Attachment 998

Words in italics denote proposed changes to Precinct Plan 1

Wiri North Precinct

FIGURE 16.13 WIRI NORTH STRUCTURE PLAN

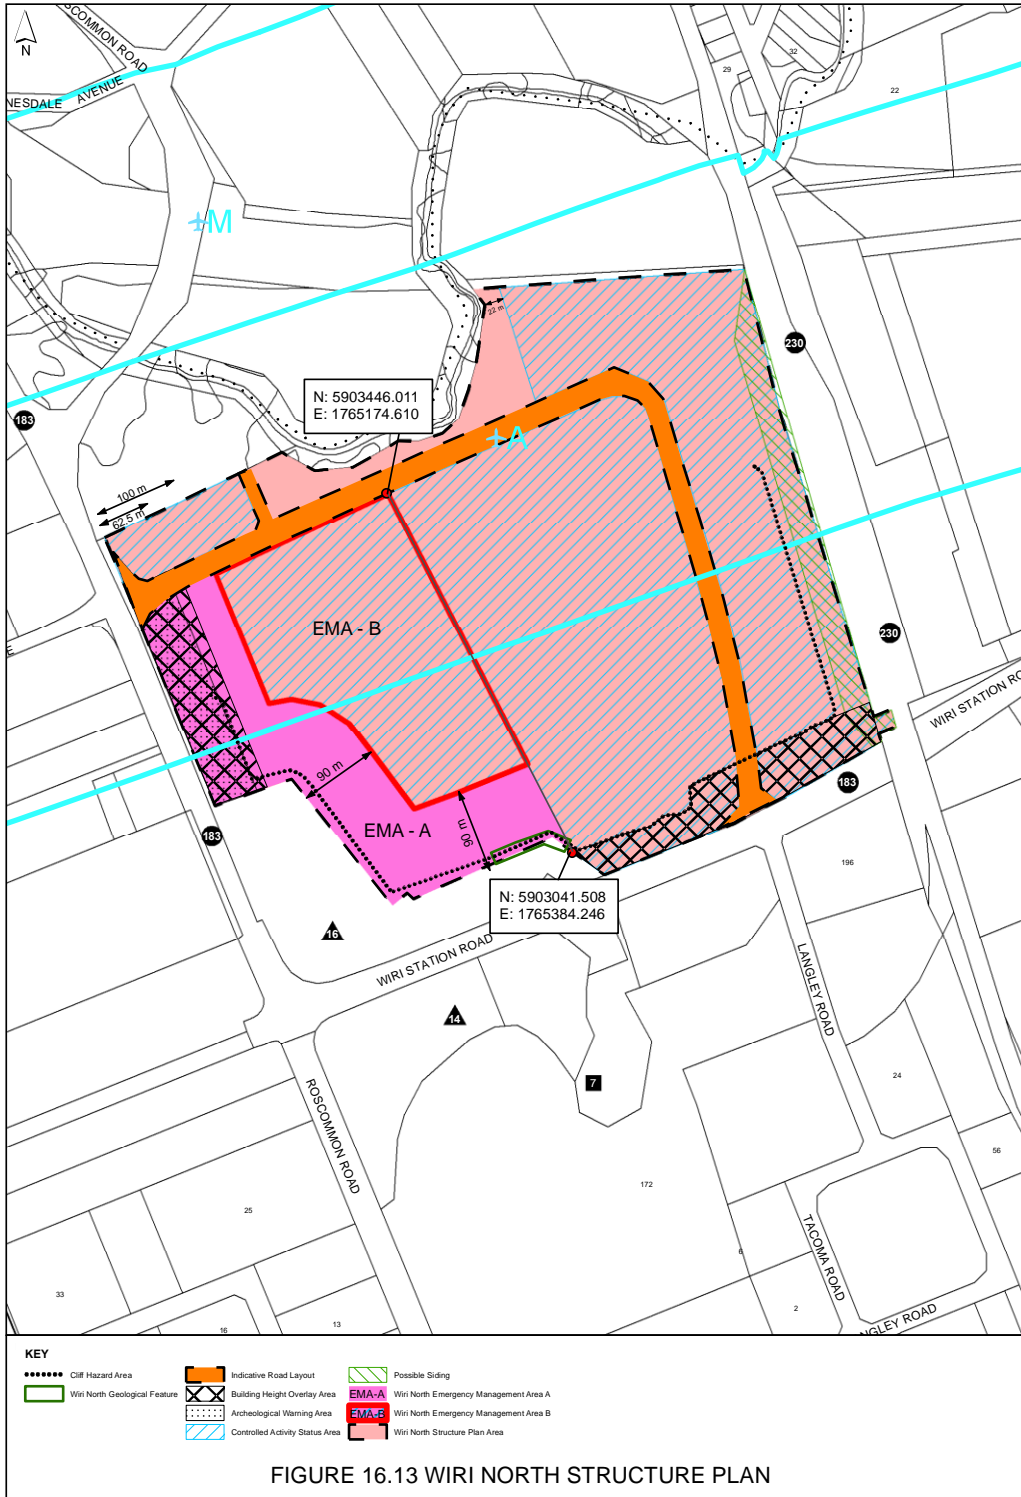
Use the following plan subject to the following changes;

- Amend the planning maps to show the whole of the precinct plan area as heavy industry zone.

- Delete:

- The lines shown as "controlled activity status area" from the map below*
- The designation numbers and the Waahi Tapu numbers*
- The blue MANA lines and associated notation*
- "Figure 16.13 Wiri North Structure Plan"*
- Reference to "Wiri North Structure Plan Area" in the key, as this will be clear from the boundary of the precinct.*
- "Possible siding" from the key and associated green diagonal overlay from map.*
